Process Sheet

Customer : CU-DAR001 Dart Helicopters Services	Drawing Name : HELI UTILITY BASKET LH/RH 350/355
Job Number : 28840	
Estimate Number : 10208	
P.O. Number : <i>N/A</i>	Part Number : D350607043
This Issue : 10/3/2006 S.O. No. : <i>N/A</i>	Drawing Number : D350-607 REV F P7-9
Prsht Rev. : NC	Project Number : N/A
First Issue : <i>N/A</i> Type : LARGE FAB ASSY	Drawing Revision : F
Previous Run : 28769	Material : <i>N/A</i>
Written By : _____	Due Date : 10/22/2006 Qty: 1 Um: Each
Checked & Approved By : <i>[Signature]</i> 06 10 03	
Comment : Est Rev:E as Per DSI9318 06-01-24 JLM

DESIGN <i>CP</i>	DRAWN BY <i>CP</i>	DART AEROSPACE LTD HAWKESBURY, ONTARIO, CANADA	
CHECKED <i>[Signature]</i>	APPROVED <i>[Signature]</i>	DRAWING NO. DSI 9318	REV. A SHEET 1 OF 1
DATE 06.01.06		TITLE WASHER ADDITION	SCALE NTS
A	06.01.06	NEW ISSUE

DART SERVICE INSTRUCTION

Figure 5- Basket Replacement Parts
(D350-607-043 Heli-Utility-Basket™)

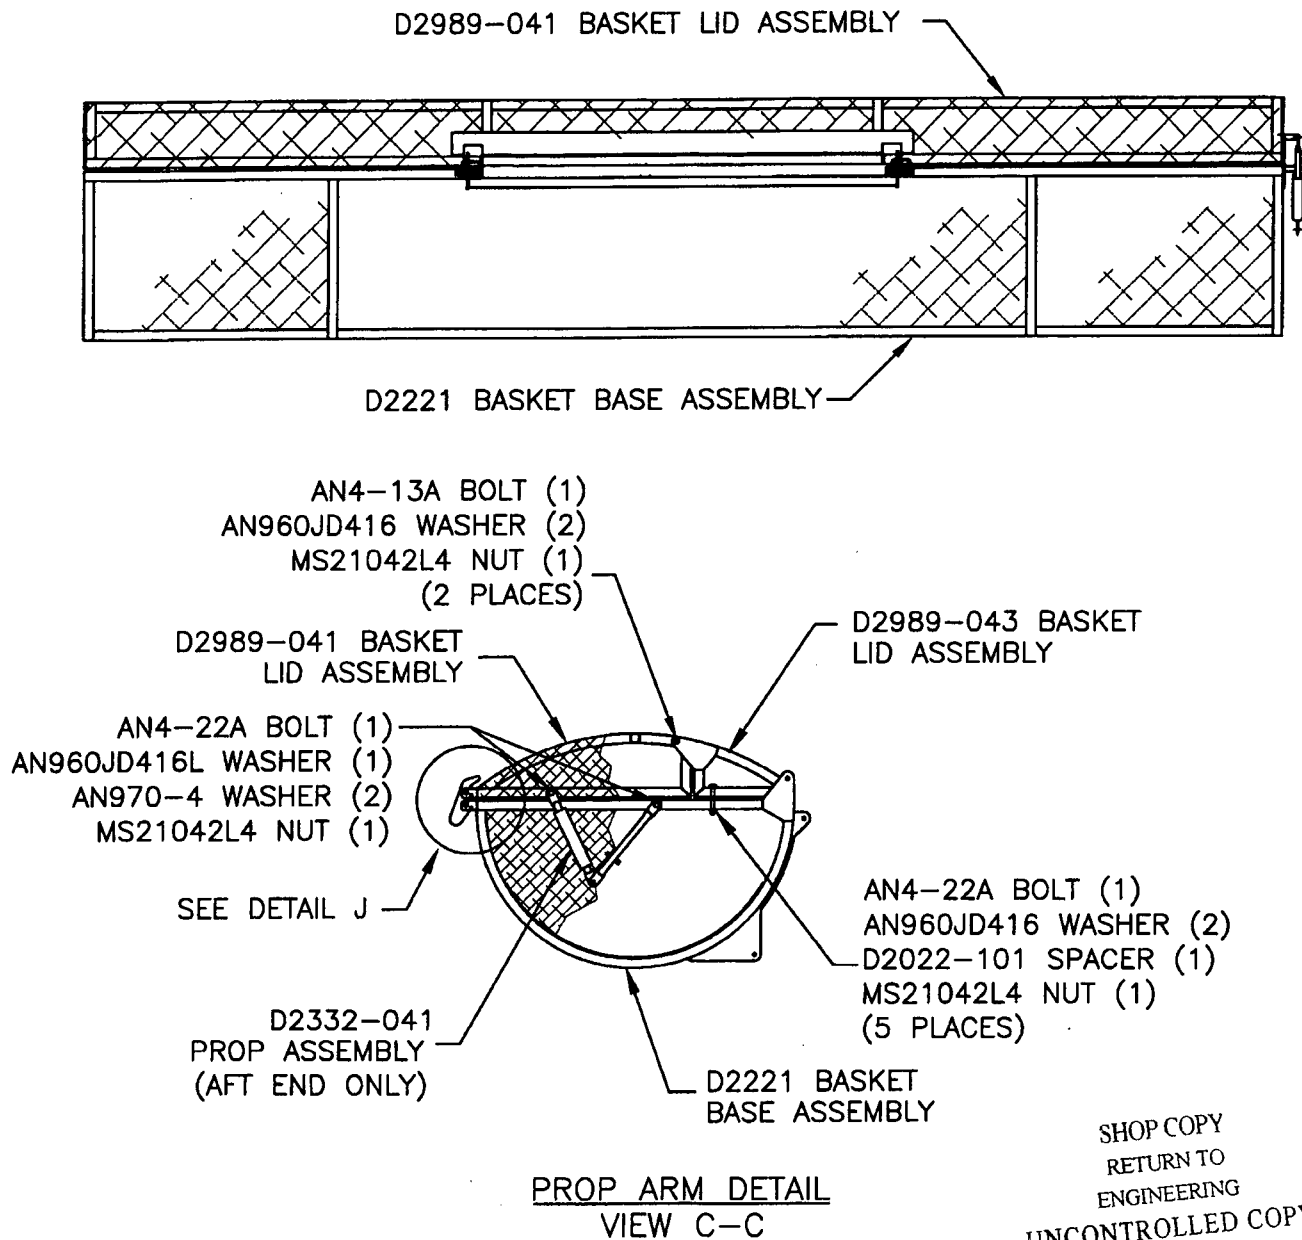
The corrected bolt stackup from Figure 5 of installation instructions D350-607 Rev. F is given below:

AN4-13A BOLT (1)
AN960JD416 WASHER (1)
HINGE PLATE (REF)
NAS1515H4 WASHER (1)
BASKET FRAME (REF)
AN960JD416 WASHER (1)
MS21042L4 NUT (1)
(2 PLACES)

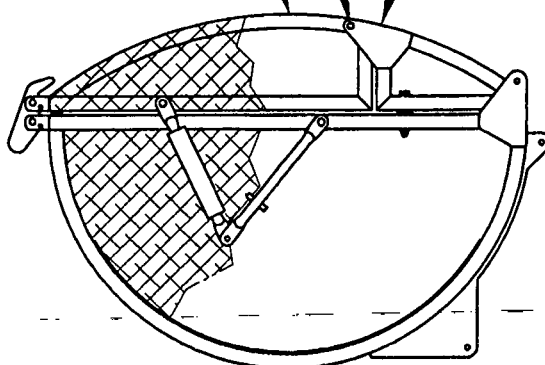
To reduce the possibility of damaging the finish, a **NAS1515H4** washer (2 places) has been added between the hinge plate and basket frame on the **D350-607-043/-047 Heli-Utility-Basket**.
